The following changes to the tender documents are effective immediately and will form part of the contract documents:

## 2 TENDER PERIOD QUESTIONS AND ANSWERS

## **5 CHANGES TO SPECIFICATIONS – ELECTRICAL**

**Image 7:** Building A1 – Conduit run to building exterior parking lot

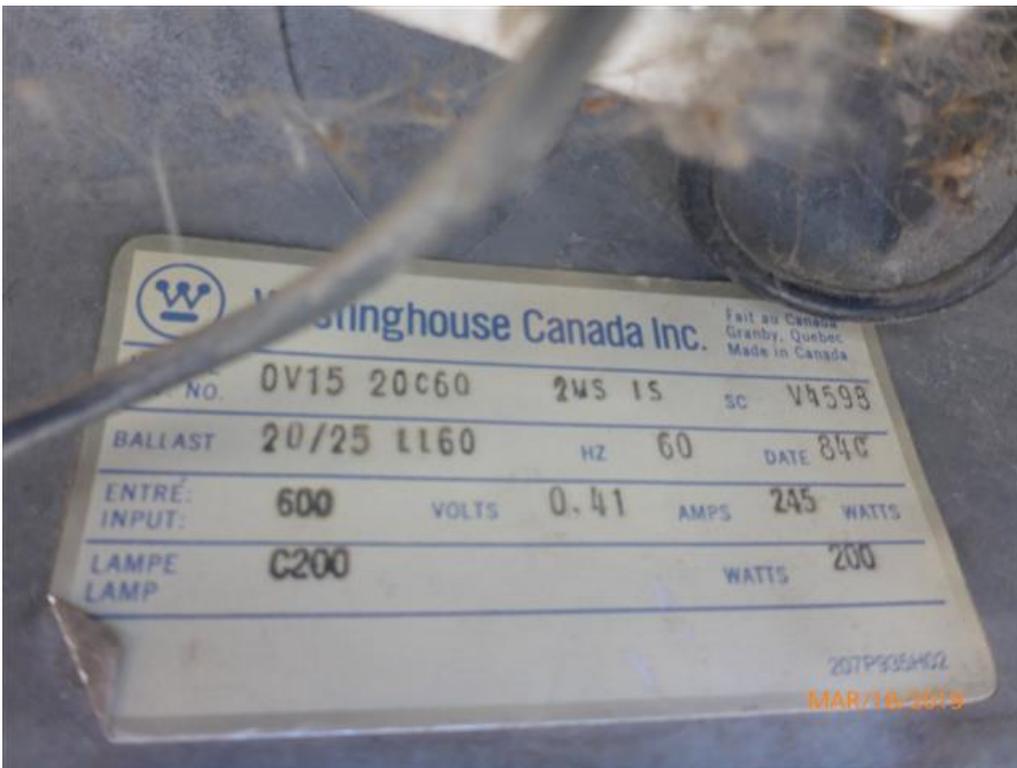
- .1 **Question:** Lighting suppliers are requesting more information on the lighting poles. Section 25 50 00 does not contain enough information to ensure the new poles match the existing poles. Please provide more information.  
**Answer:** Existing site lighting images of lamp post and remote head make and model included as part of the attached photo library.
- .2 **Question:** Please provide pictures of equipment to be demolished inside C12 Powerhouse.  
**Answer:** Existing equipment to be demolished inside C12 Powerhouse included as part of the attached photo library.
- .3 **Question:** Can you give more details on underground tunnels, ie, width and depth?  
**Answer:** Typical tunnel dimensions are 6'-0" (width) x 7'-0" (height) with mechanical chases on both sides running along the tunnel. Average clearance between chases is 3'-0".
